Land at Chesapeake, Sayers Common: Transport Statement Addendum

Ref: TW/BB/ITB200420-004A TN
Date: 11 December 2025

DRAWN: JD	CHECKED: BB	APPROVED: TW
PROJECT No: ITB200420	SCALE @ A3: 1:500	DATE: 17.02.25
DRAWING No: ITB200420-GA-001	REV: C

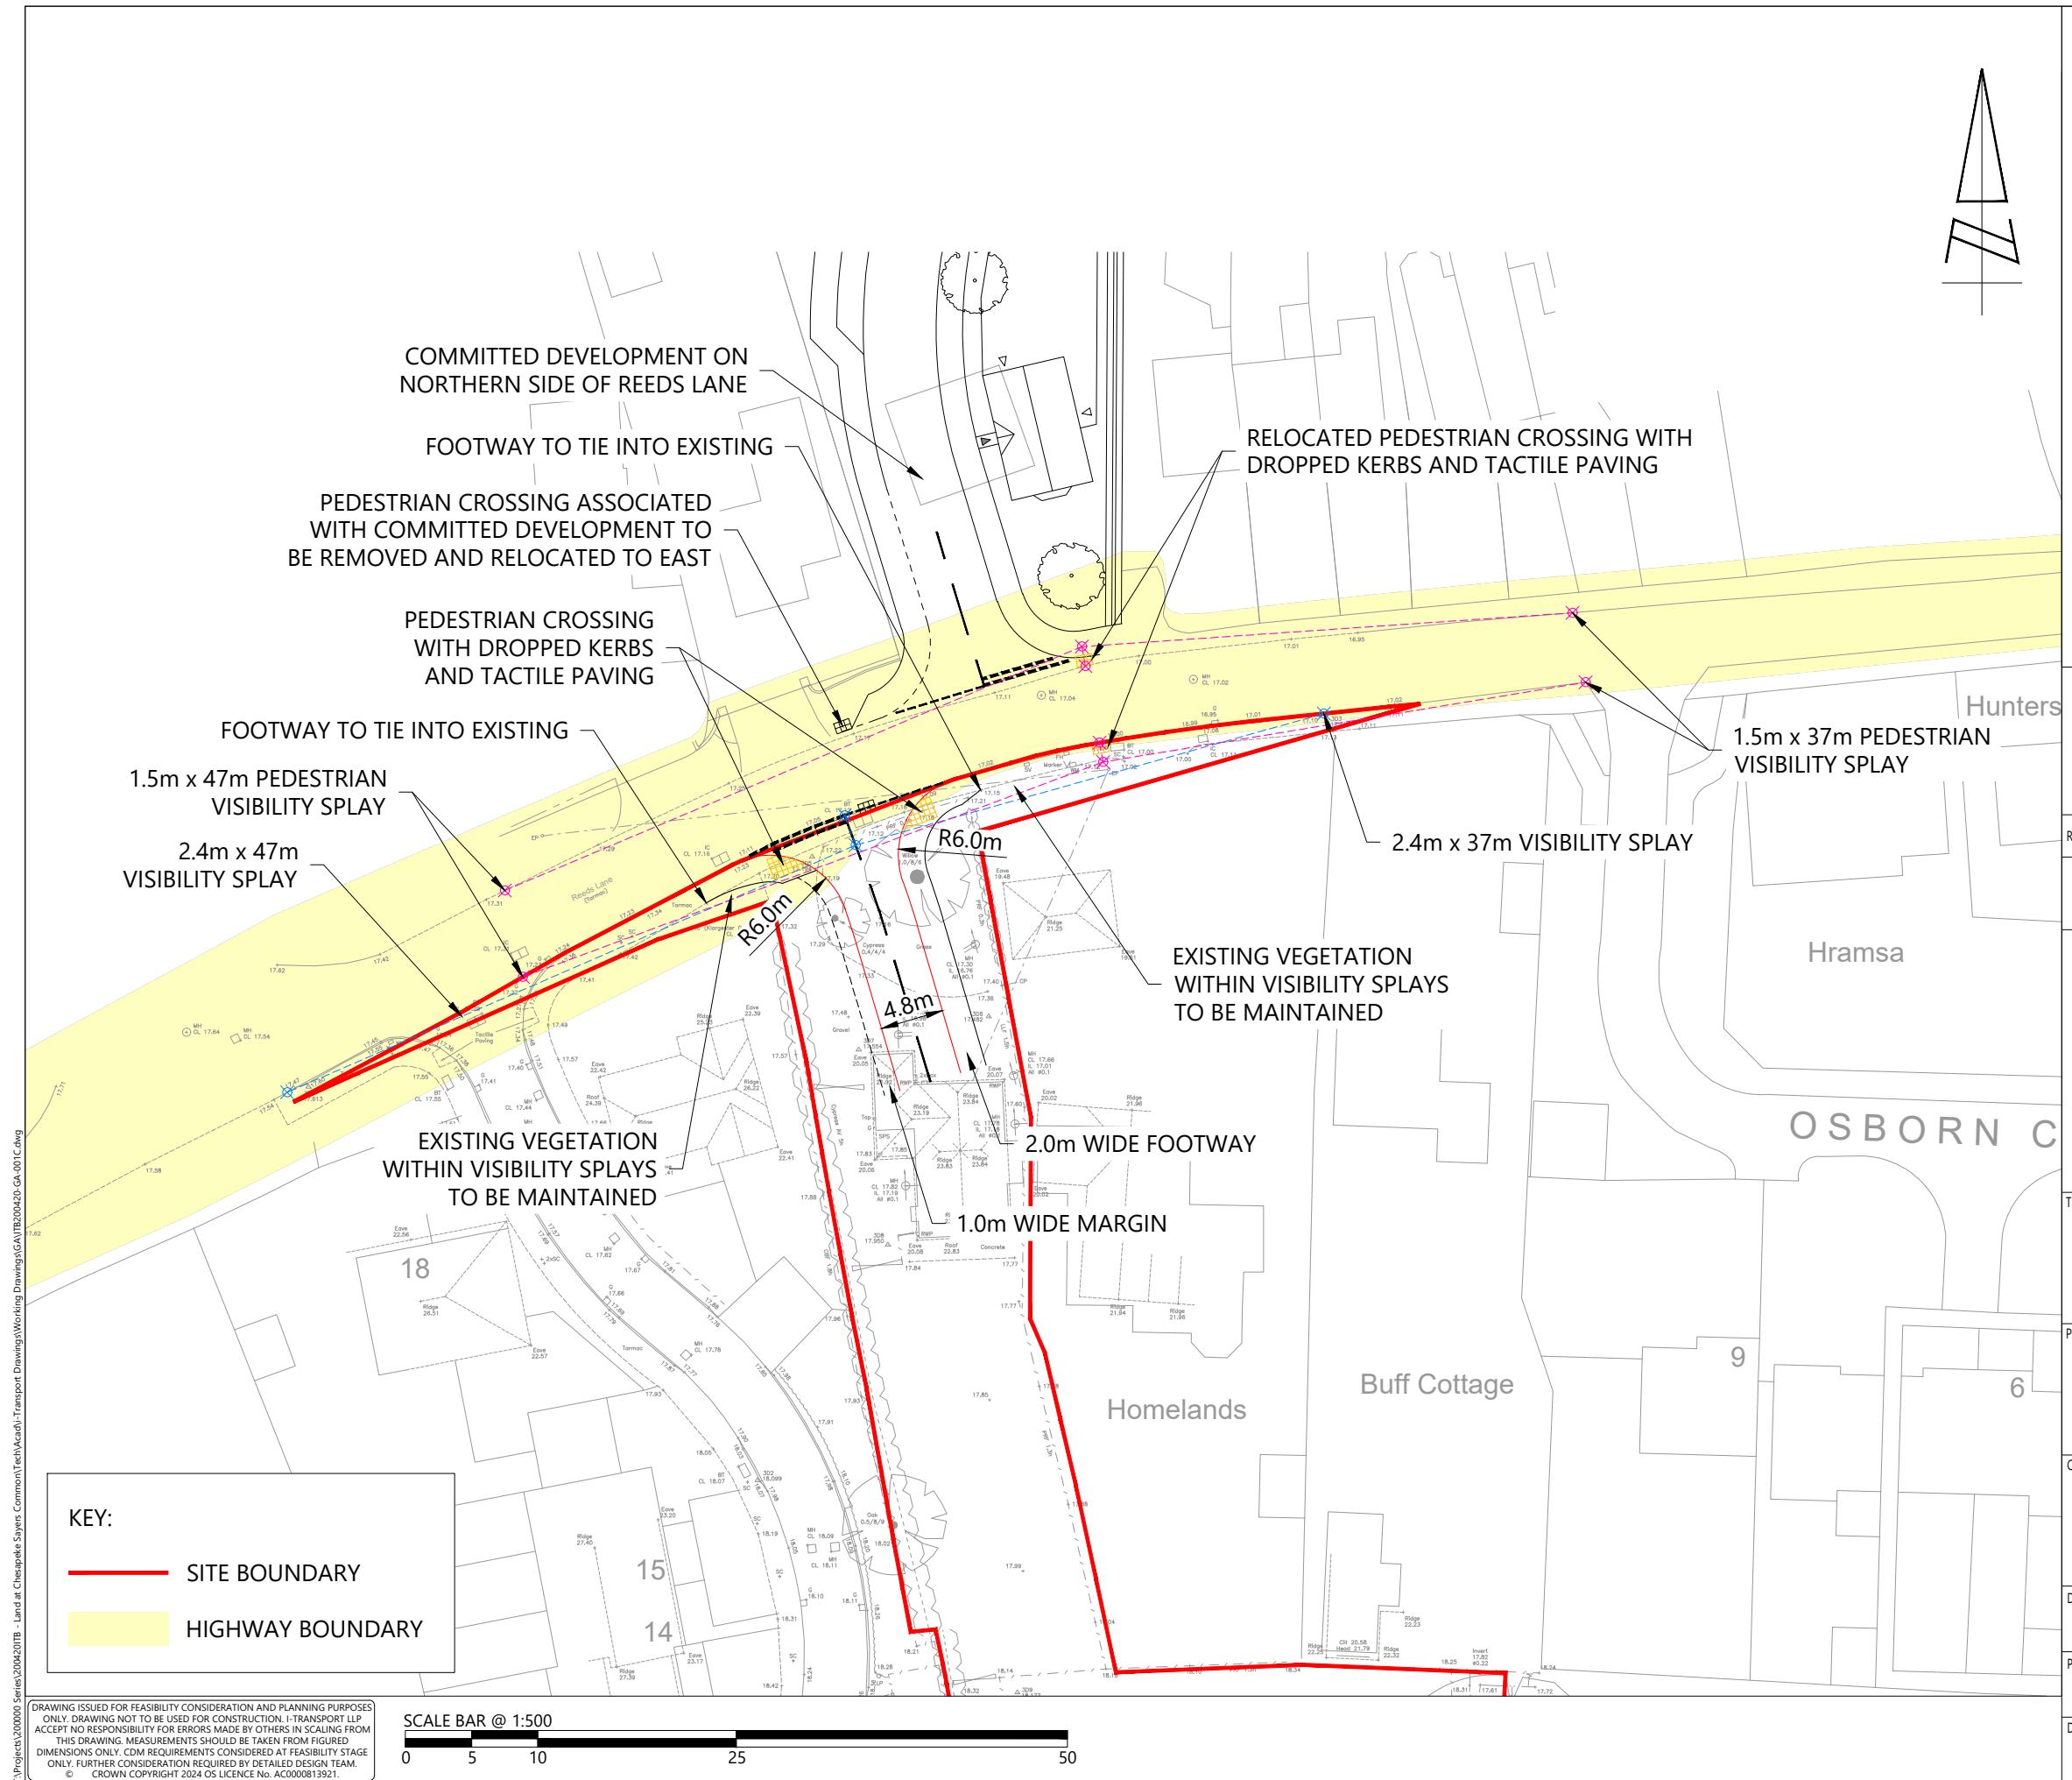
3.1.2 However, in relation to Problem 1, which concerned the possibility for on-street car parking on Reeds Lane to obstruct visibility splays at the newly proposed site access junction, WSCC requested that an updated response be provided to the Auditor.

1 – risk of obstructed visibility east of site access due to parked cars – auditor recommends appropriate visibility splays – Designers respond that on-street parking within 10 metres junction would be in contravention of Highway Code (parking within this would apply to new junction and that of Meadow View). Designer has welcomed parking restrictions at detailed design stage – if this is considered necessary. The WSCC Highways Agreement Engineer has been consulted in respect to whether providing such parking restrictions at detailed design stage would be acceptable (or whether this should be agreed at planning/ Stage 1 RSA stage). His comments are awaited. Considering the auditors recommendation did not include parking restrictions as a solution, but did advise that suitable visibility splays are demonstrated, the LHA also recommend that these are provided to auditor along with any justification for parking within these splays i.e. Manual for Streets 2 para. 10.7.1, 10.4.2.

RSA Problem	RSA Recommendation	Design Organisation Response	Overseeing Organisation Response	Agreed RSA Action
<p>1: Parked cars were observed on Reeds Lane, outside the two dwellings (Nos. 1 & 2 Meadow View) adjacent and to the west of the site access. This may obstruct visibility splays at the new site access. This may result in side-swipe collisions between existing vehicles and those passing along Reeds Lane.</p>	<p>Ensure appropriate visibility splays can be achieved.</p>	<p>Acknowledged – MfS2 (at Paragraph 10.7.1) states that parking in visibility splays is common although does not cause significant problems in practice. This is, in part, due to the transitory nature of on-street parking, which ensures that visibility splays are only ever impeded on a temporary basis. Rule 243 of the Highway Code also states that vehicles must not park opposite, or within 10 metres, of a junction or access. The creation of the new site access junction will therefore itself serve to limit on-street parking within its vicinity. Furthermore, research carried out in conjunction with the drafting of MfS2 found no evidence to suggest that the failure to provide visibility at priority junctions results in an increased risk of injury collisions. Therefore, any temporary restrictions to visibility as a result of on-street parking are not considered to be inherently unsafe. However, as set out above, the transitory nature of on-street parking will ensure that any restrictions to visibility will only ever occur on a temporary basis.</p> <p>Notwithstanding the above, if deemed necessary at the detailed design stage, parking restrictions in the form of signing and lining could be introduced to prevent on-street parking within the vicinity of the site access.</p>	<p>Considering the Auditor's recommendation did not include parking restrictions as a solution, any justification for parking within visibility splays should be provided to the Auditor, i.e. Manual for Streets 2.</p>

RSA Problem	RSA Recommendation	Design Organisation Response	Overseeing Organisation Response	Agreed RSA Action
<p>2: The width of the site access appears relatively narrow. Swept path analysis indicates that there is insufficient space for two vehicles to pass each other at the northern extent. The access road has a meandering alignment, while there is vegetation along Reeds Lane. This may cause obstructions to visibility for both entering and exiting vehicles. This may result in head-on or side-swipe type collisions when vehicles turn into the site.</p>	<p>Provide passing places or sufficient width to allow vehicles to pass on the site access.</p>	<p>Acknowledged – Figure 7.1 of the Manual for Streets (MfS) indicates that a 4.8m wide carriageway width is suitable for two cars to pass one another comfortably. Furthermore, guidance in paragraph 6.8.1 of MfS states that along streets with low traffic flows (such as the proposed on-site street) it can be assumed that larger vehicles (such as service vehicles) can use the full width of the carriageway to manoeuvre. On this basis, a 4.8m wide carriageway width is suitable to serve the proposed development.</p> <p>Notwithstanding this, additional swept path analysis of two large estate cars has been undertaken. The tracking is shown as drawing no. ITB200420-GA-007 and demonstrates that two large cars are able to pass one another simultaneously at the proposed site access and along the full length of the internal site access road on approach to the site access junction. Moreover, an internal visibility assessment (shown as drawing no. ITB200420-GA-005B) demonstrates that appropriate forward visibility is provided around the bends in the site access road – based on a 20mph design speed.</p> <p>A note has also been added to the proposed access drawing to confirm that any vegetation within the extent of the visibility splays will be maintained appropriately. This will ensure no impact on visibility for approaching/emerging vehicles. The updated drawing is shown as drawing no. ITB200420-GA-001C.</p>	<p>-</p>	<p>-</p>

RSA Problem	RSA Recommendation	Design Organisation Response	Overseeing Organisation Response	Agreed RSA Action
3: The site will include a tactile paved crossing facility. The crossing is set back away from the desire line. This may cause visually impaired pedestrians (VIPs) not to detect the crossing. This may result in VIPs falling in the carriageway when encountering full-height kerbs.	Relocate pedestrian crossing onto the pedestrian desire line.	Accepted – the proposed pedestrian crossing has been relocated further to the north to ensure it is on the pedestrian desire line. The updated proposals are shown on drawing no. ITB200420-GA-001C .

3.1.3 In recognition of WSCC's comments, the Designer Response to the Stage 1 Road Safety Audit has therefore been updated, and is contained at **Appendix C**. The updated Designer Response now includes reference to Manual for Streets 2, paragraphs 10.7.1 and 10.4.2, by stating:

- 1 That parking within visibility splays is common and does not create significant problems in practice – this is, in part, due to the transitory nature of on-street parking.
- 2 That research carried out in conjunction with the drafting of MfS2 has found no evidence to suggest that the failure to provide visibility at priority junctions results in an increased risk of injury collisions – this is also mitigated by the transitory nature of on-street parking, which ensures that the visibility splays at the proposed site access junction will only be restricted by on-street parking on a temporary basis.

3.1.4 We can confirm that the Auditor was provided the latest proposed site access design: **ITB200420-GA-001C** (as submitted within the Transport Statement), with the associated 2.4m x 47m and 2.4m x 37m visibility splays, which WSCC confirmed their agreement to within their consultation response.

3.1.5 The updated Designer Response has been issued to the appointed independent Auditor, who has confirmed that there remain no residual safety concerns with the proposed site access design. Their updated response is contained at **Appendix C**.
